Project	IEEE 802.16 Broadband Wireless Access Working Group < http://ieee802.org/16 >	
Title	OFDM Frame Structure	
Date Submitted	2002-01-11	
Source(s)	Lei Wang Brian Gieschen Wi-LAN Inc. 2891 Sunridge Way, NE Calgary, AB, Canada, T1Y 7K7	Voice: (403)273-9133 Fax: (403)273-5100 Email: LeiW@wi-lan.com ; BrianG@wi-lan.com ;
Re:	This is a contribution to IEEE 802.16 TGa.	
Abstract	This contribution combines two subsections for the OFDM Frame Structure in 802.16a/D1 document and provides an improved description.	
Purpose	To Enhance the OFDM Frame Structure definition and description in 802.16a/D1.	
Notice	This document has been prepared to assist IEEE 802.16. It is offered as a basis for discussion and is not binding on the contributing individual(s) or organization(s). The material in this document is subject to change in form and content after further study. The contributor(s) reserve(s) the right to add, amend or withdraw material contained herein.

3 Suggested Text for Section 8.3.5.3.3.1

8.3.3.3.3.1 OFDM Frame Structure

FIGURE 210 Frame Structure for the OFDM PHY with TDD

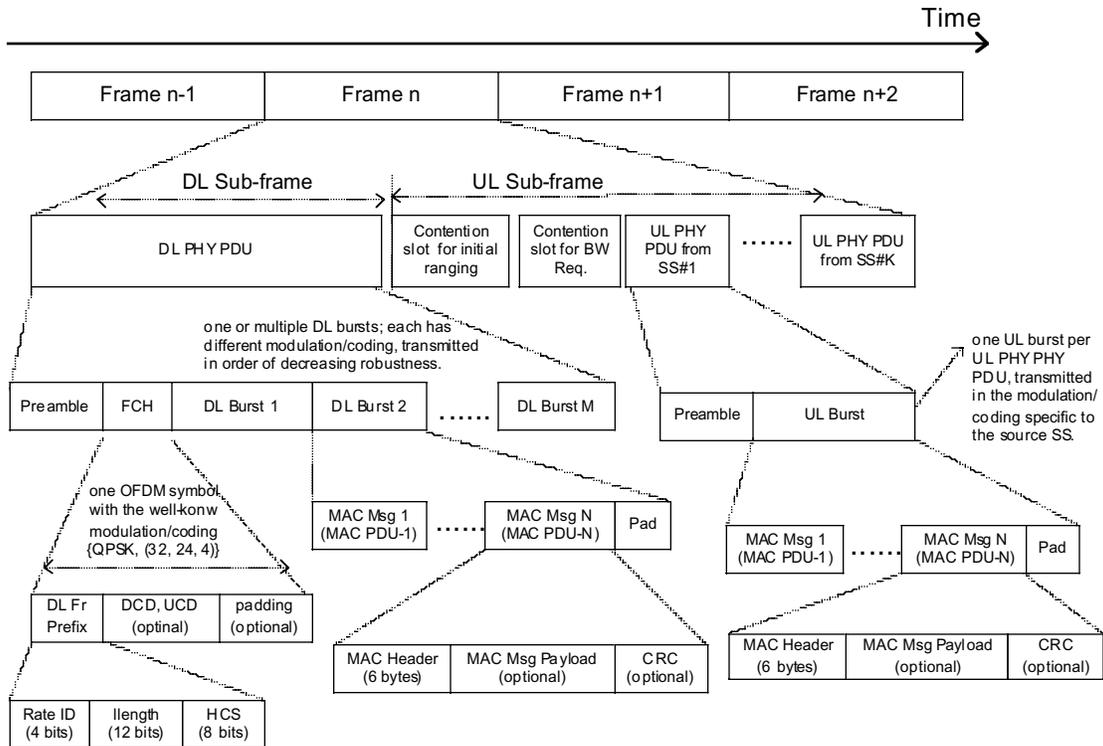
The frame interval contains both transmissions (PHY PDUs) of BS and SSs and guard intervals. Figure 210 and Figure 211 show the frame structures for the OFDM PHY with TDD and FDD, respectively.

A frame consists of a DL sub-frame and an UL sub-frame. A DL sub-frame consists of only one DL PHY PDU. An UL sub-frame consists of contention intervals scheduled for initial ranging and bandwidth request purposes and one or multiple UL PHY PDUs, each transmitted from a different SS.

A UL PHY PDU consists of only one burst, which is made up of a preamble and an integer number of OFDM symbols. The burst PHY parameters of an UL PHY PDU are specified by a 4-bit UIUC (Uplink Interval Usage Code) in the UL-MAP. The UIUC encoding is defined in the UCD(Uplink Channel Descriptor) messages.

A DL PHY PDU starts from a preamble, which is used for PHY synchronization. The preamble is followed by a FCH (Frame Control Header) burst. The FCH burst is one OFDM symbol long and is transmitted in a well-known modulation/coding: {QPSK, (32,24,4)}. The FCH is followed by one or multiple DL bursts, each transmitted with different PHY parameters and therefore different level of transmission robustness. If there are multiple DL bursts in a DL PHY PDU, they are transmitted in order of decreasing robustness. Each DL burst consists of an integer number of OFDM symbols, and its burst profiles (PHY parameters) are specified by a 4-bit DIUC (Downlink Interval Usage Code) in the DL-MAP. The DIUC encoding is defined in the DCD (Downlink Channel Descriptor) messages.

FIGURE 211 Frame Structure for the OFDM PHY with FDD

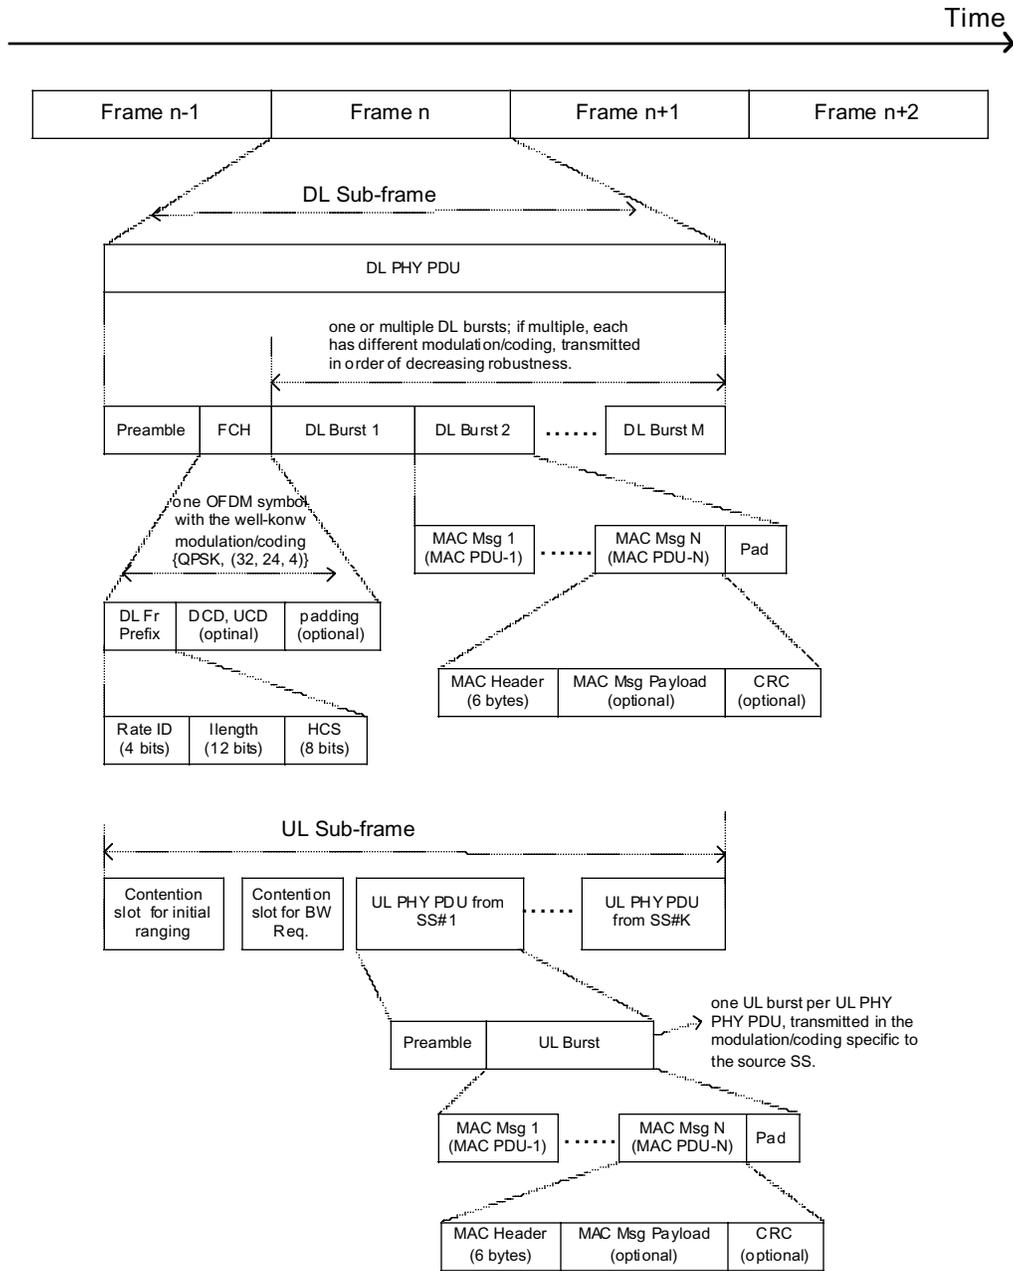
In a DL PHY PDU, a special PHY burst, FCH (Frame Control Header), is used to specify the burst profiles and length of the DL burst-1, that is, the DL burst immediately following the FCH. The FCH is one OFDM symbol long and transmitted with a well-known burst profiles, i.e., {QPSK, (32,24,4)}. The FCH uses the 4-bit Rate_ID to specify the burst profiles of the DL burst-1. The Rate_ID encoding is defined in Table 197. The difference between the Rate_ID and DIUC is whether or not the encoding can be dynamically
